Environmental Review Team Report
Green Hollow Subdivision
Plainfield, Connecticut

Environmental Review Team
Report

Green Hollow Subdivision
Plainfield, Connecticut

June 1983

Surficial Geology

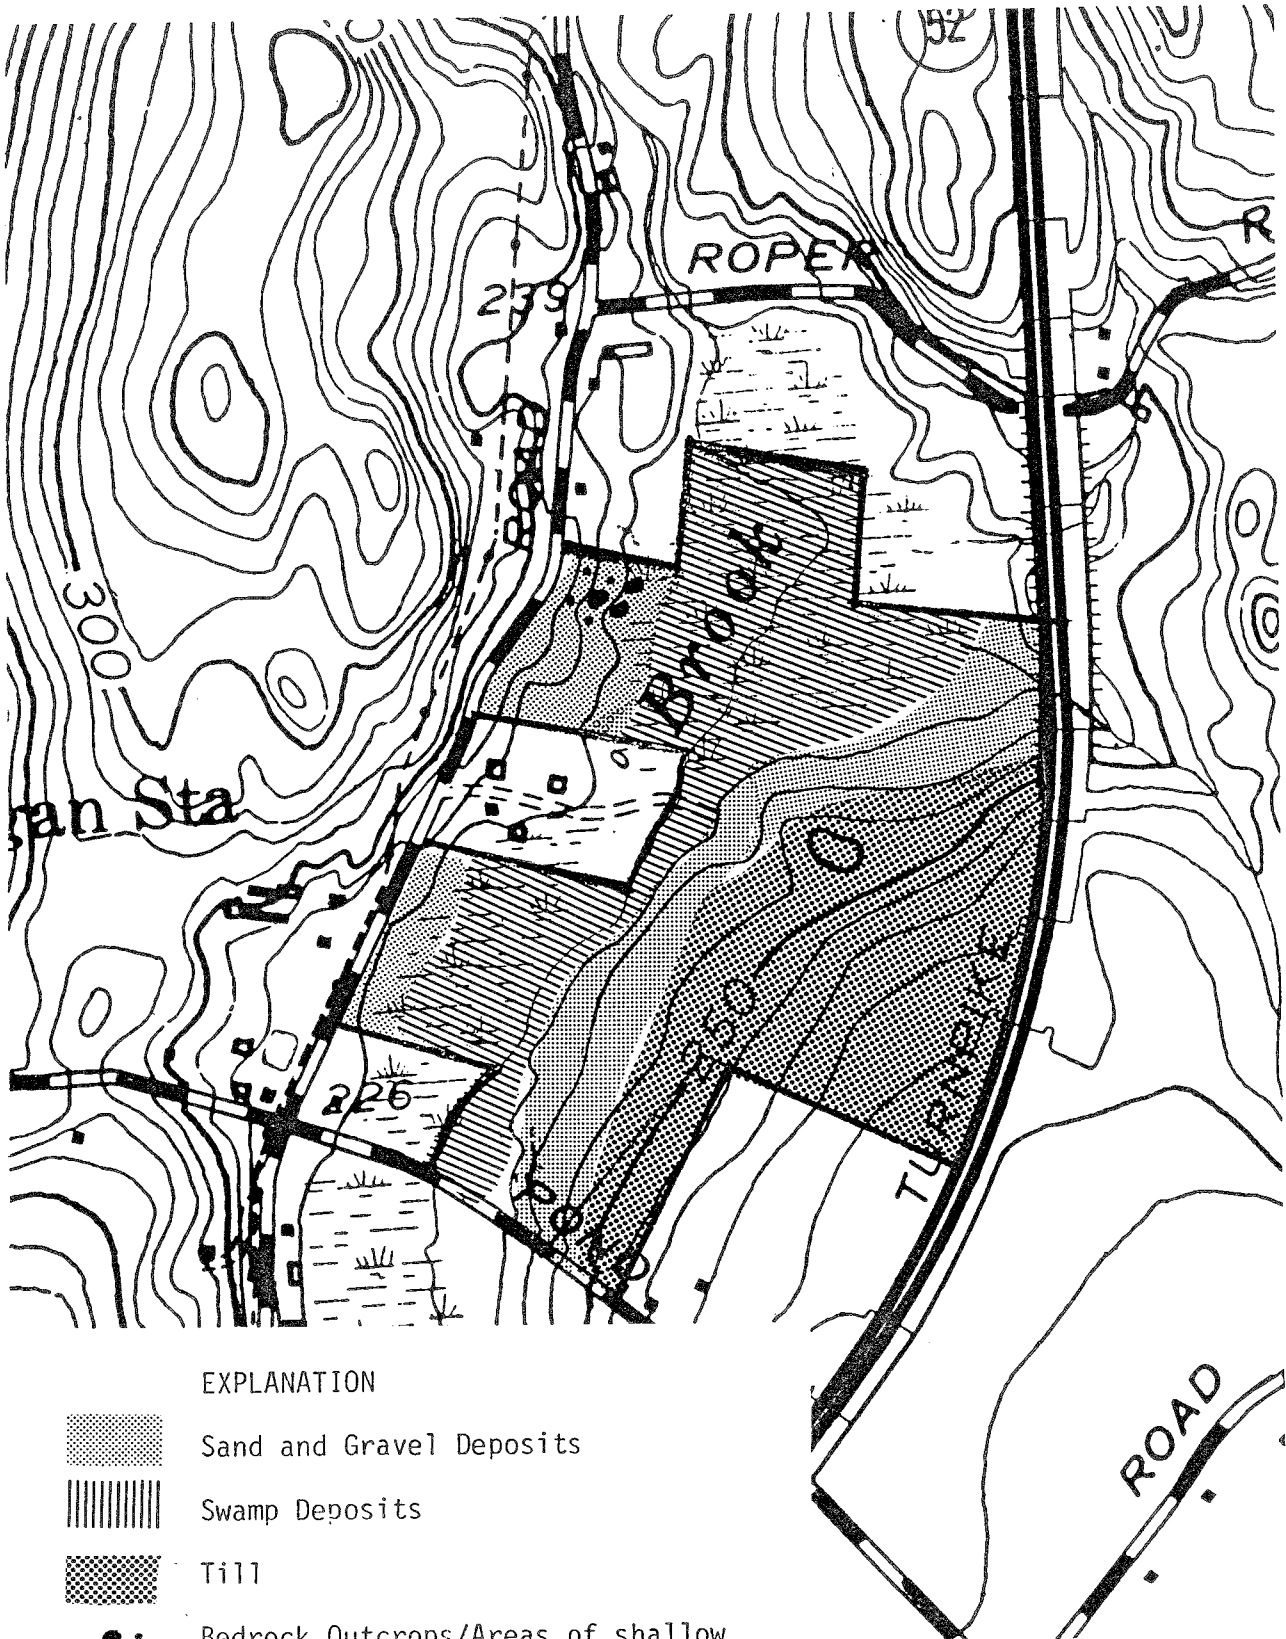
The principal surficial material (material which overlies solid bedrock) on the site is a pebble-cobble gravel and sand which was deposited by glacial melt-water streams. These deposits range in thickness from nothing where outcrops occur in the northwest section of the parcel, to 40 feet beneath the wetland in the middle section of the site. Based on visual inspection of Lots 9-11 and information supplied to the Team, it was observed that sand and gravel deposits had been extracted from various portions of these lots. As a result of the extraction operation, only ± 18 " of soil was left between ground surface and the ground water table, which has created an area of special concern with respect to on-site sewage disposal. Since the Public Health Code requires a minimum separating distance of 18 inches between the bottom of leaching areas and maximum ground water elevations, sewage disposal systems on these lots will no doubt require engineering. Once plans are designed, they would be reviewed for possible approval by both the local and state Health Departments. Another type of glacial

deposit, found throughout the eastern section of the site, is till. This sediment consists of rock particles and fragments that were accumulated by moving glacier ice and later redeposited directly from the ice. Because the ice collected rock particles of all sizes and since these particles were not sorted by meltwater, till contains everything from clay to boulders. The texture of till deposits in this area are estimated at 40 feet or more in thickness. Based on a test hole boring along Route 52, which is east of the property, till was encountered to a depth of 78 feet below ground level. (Source: Connecticut Water Resource Bulletin No. 8.). Swamp deposits are the only other significant deposit on the site. These sediments, which are confined to the middle section of the site consists of sand, silt, clay and a high percentage of organic material (decayed plant matter). Swamp deposits are generally 5-8 feet thick and probably underlain by sand and gravel.

Drainage Areas

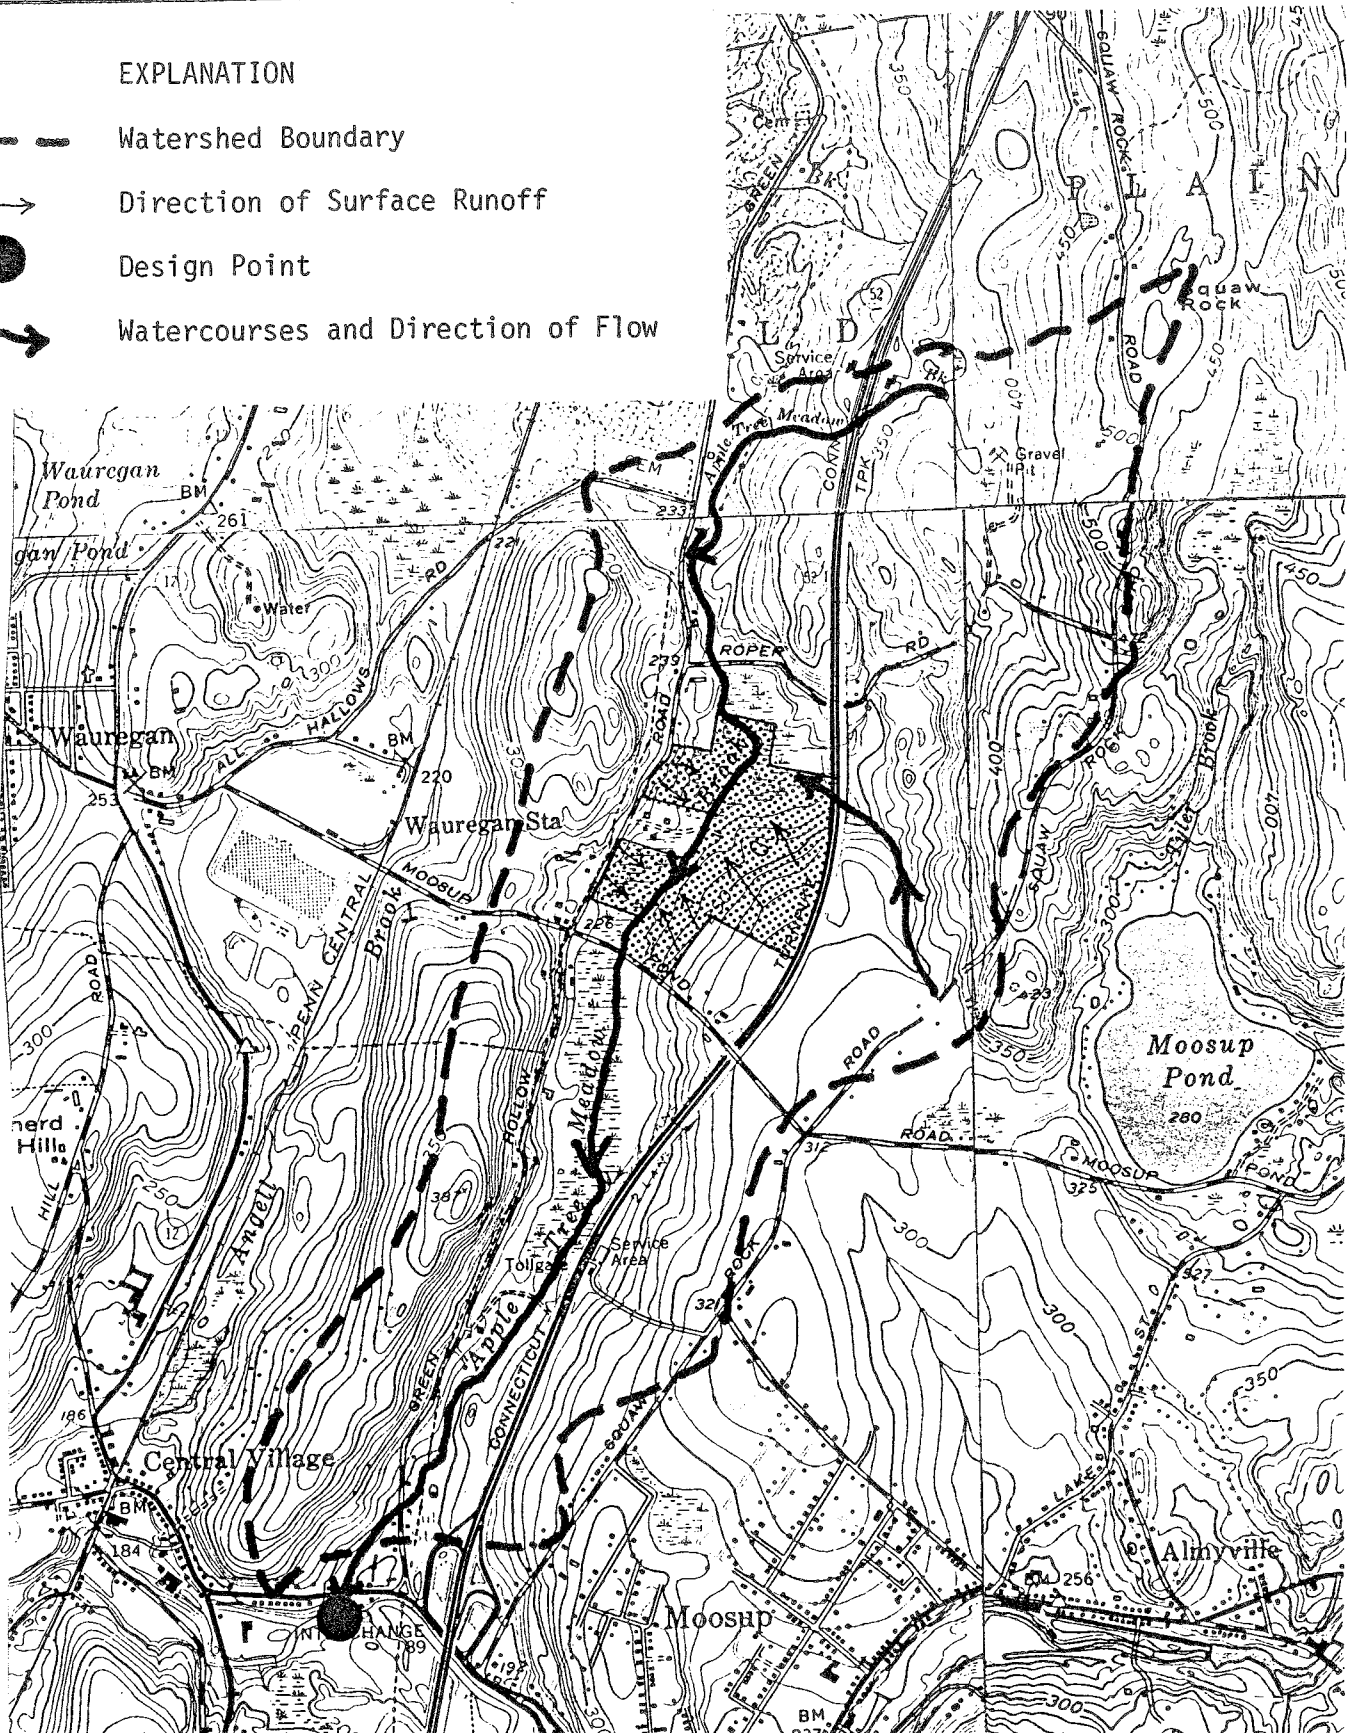
The entire site lies within the watershed of Apple Tree Meadow Brook. Apple Tree Meadow Brook, which ultimately discharges into the Moosup River, flows through the middle section of the site. The drainage area of the watershed is \pm 1350 acres. (2.11 square miles).

Development of the site to the extent presently planned would generate additional runoff for a given rainfall. Factors affecting the actual increase of runoff would include: (1) the construction of impervious surfaces, i.e., paved roads and roof tops. (2) removal of vegetation and compaction of soils during the construction phase (3) waste water discharges particularly from septic systems. Based on visual inspection of the site, it appears that runoff, as well as a potential erosion and sedimentation problems would be of more concern with respect to Lots 7-11. The reason for this is these areas were observed to have a high ground water condition. Therefore, it is recommended that the developer direct his attention to these areas by preparing and implementing a careful sediment and erosion control plan. The plan should include measures that will prevent potential problems to the wetland and Apple Tree Meadow Brook. Based on deep test hole information and soil maps, the sandy/gravelly soil found throughout Lots 1-6 are well drained and would probably have low surface runoff potential.

Soils

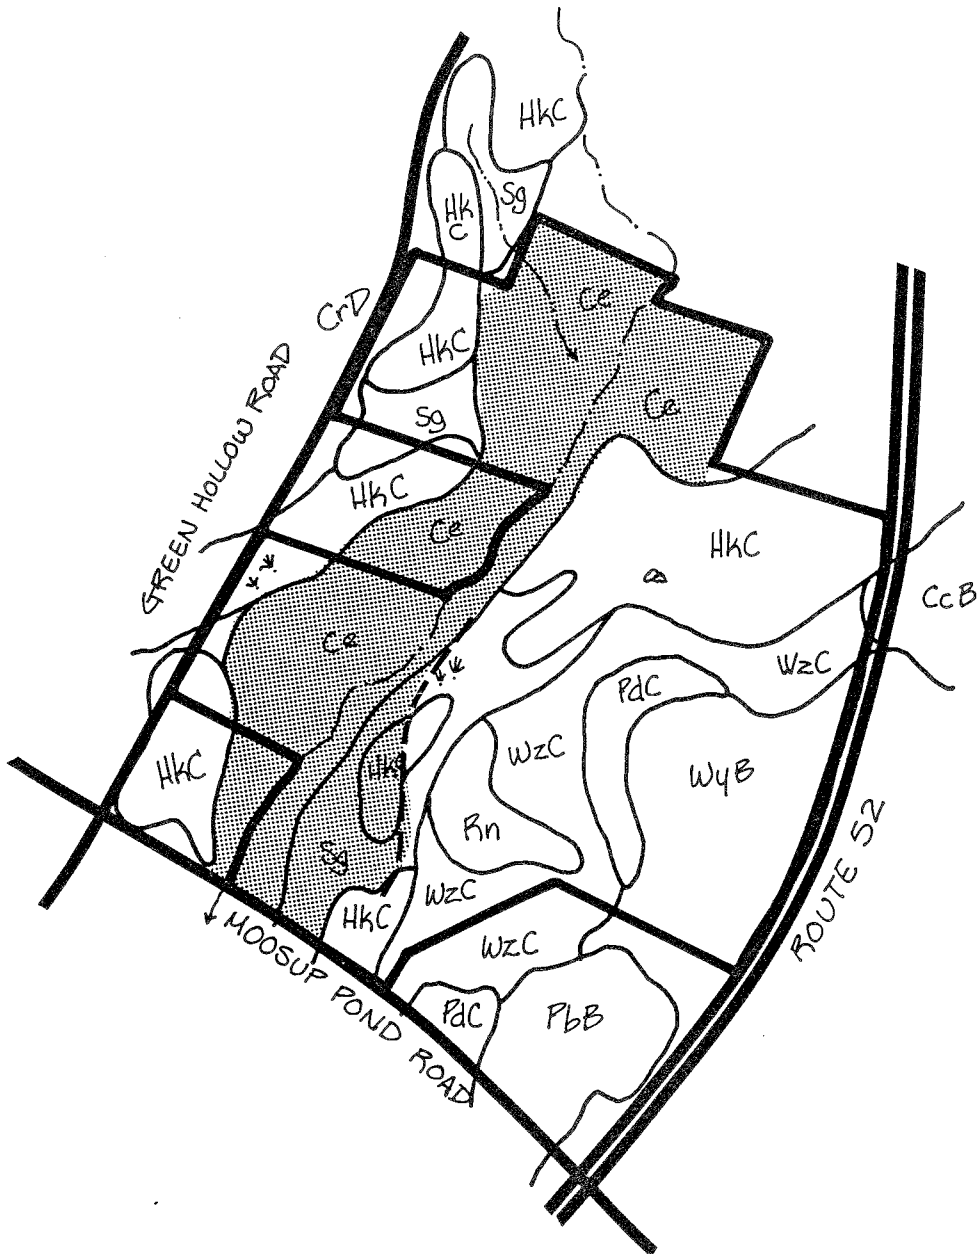
The soils are distributed as indicated by the detailed soil map except for the areas along Moosup Pond Road noted as altered on the soil map. These areas consisted of soils of the Hinckley and Sudbury series when mapped, but have since been altered. They were excavated several years ago and stripped for gravel. Excavations in some areas were to the level of the water table. The top soil was replaced, thus making these areas appear undisturbed. However, upon investigation these areas were found to be poorly drained. The boundary of the wet soils were flagged in the field and pointed out to the owner, Mr. Corson, and to John Valenti from the Northeast District Department of Health.

The surface rock outcrops in the front of Lots 1 and 2 may need to be blasted to allow a cellar foundation and driveway. It appears possible to install on-site septic systems into the well-drained Hinckley soil downslope beyond the ledge. Leachate from these systems will inevitably drain to the wetlands and aquifer.

A driveway entering Lots 3 and 4, as shown will require between 10 and 15 feet of fill material. It is important to build up a relatively flat length of driveway at the road to allow visibility over the hood of a car. Due to the road's curve and very limited sight distance in either direction entering the road is dangerous here. It is suggested that Lots 3 and 4 might be made one lot with an entrance drive located at the present boundary of Lots 2 and 3. Visibility is much better here. Final grade lines should be shown on the subdivision plan.

Concerns for driveway entrances and foundation excavations are minimal on Lots 5 and 6. There are several wet spots near the road. It would be wise to use footing drains and grade the yard away from foundations. Driveways should be graded to direct water away from the foundations. A paved bump (or berm) could be installed at the road edge to prevent road runoff from flowing down the drive. Again septic system leachate will drain to the wetland and aquifer.

Lots 7 and 8 are limited by seasonally high water table, low elevation subject to periodic flooding, an 18 inch diameter road culvert entering Lot 7 which provides a steady flow of water across this area, and the need to fill wetlands if developed. Use of these lots for homes is discouraged. Lot 6 might be made larger encompassing Lots 7 and 8.

Lots 9, 10, and 11 front Moosup Pond Road. Original native soils on Lot 9 and a major portion of 10 have been disturbed. As previously mentioned, the boundary of the wet soils has been flagged on the land. Water was seen standing in test pits dug on these lots. It is recommended that building not be allowed within these wetland areas. This low land may be subject to flooding now during severe storms depending on elevation above the brook. If building is allowed on filled material, installation of footing drains and surface graded swales to direct runoff away from a house located lower down the slope is advisable. All final grading at two (2) foot contour intervals should be shown on the subdivision plan.

Vegetation

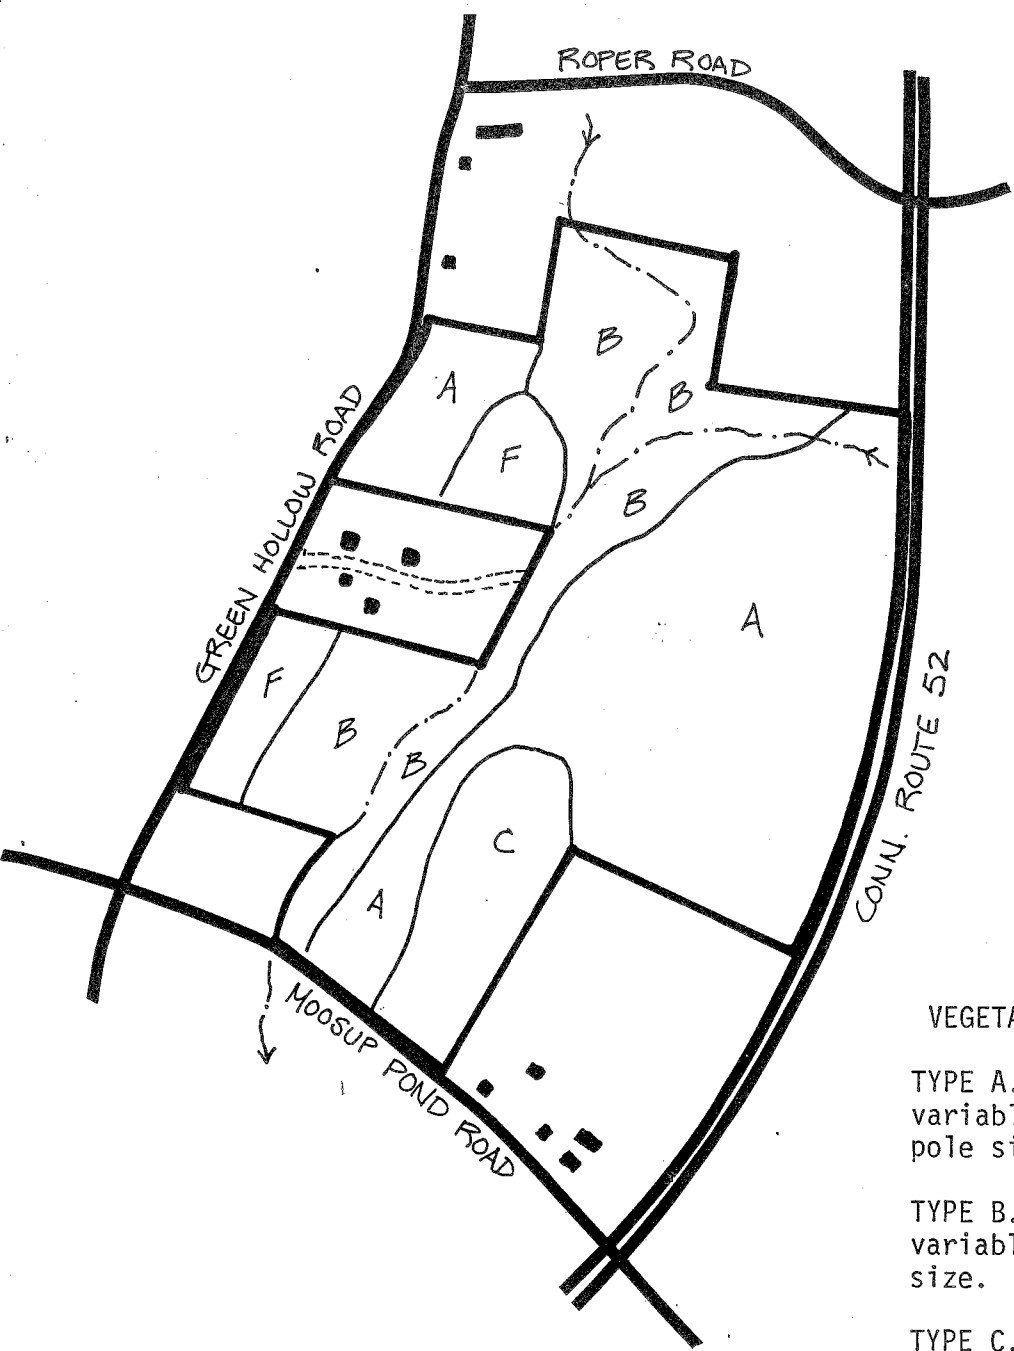
The trees which are present in Vegetation Type C (Mixed Hardwoods) and parts of Vegetation Type B (Hardwood Swamp) are declining in health and vigor as a result of their crowded condition. Periodic fuelwood thinnings that are focused on the removal of the poorest quality trees in the overstory, removing no more than $\frac{1}{4}$ of the total cordwood volume, will reduce the crowded condition enough to allow the residual trees to respond with improved health, vigor and stability.

To avoid irreversible soil damage, due to the high soil moisture level, thinning operations in these stands should only be implemented during the winter months when the ground is frozen or the summer months when the ground is dry. Many portions of Vegetation Type C will be inoperable to conventional harvesting equipment.

The open areas of Vegetation Type A (Old Field) could be planted to conifer species to improve the aesthetic quality of the area, improve cover conditions for wildlife and eventually provide a potential sawtimber crop. Conifers such as eastern white pine, hemlock, Norway spruce or larch could be planted. The trees should be planted in a random mixture at a spacing of 8 to 12 feet apart. They will not require intensive management, however, some initial grass and weed control may be necessary.
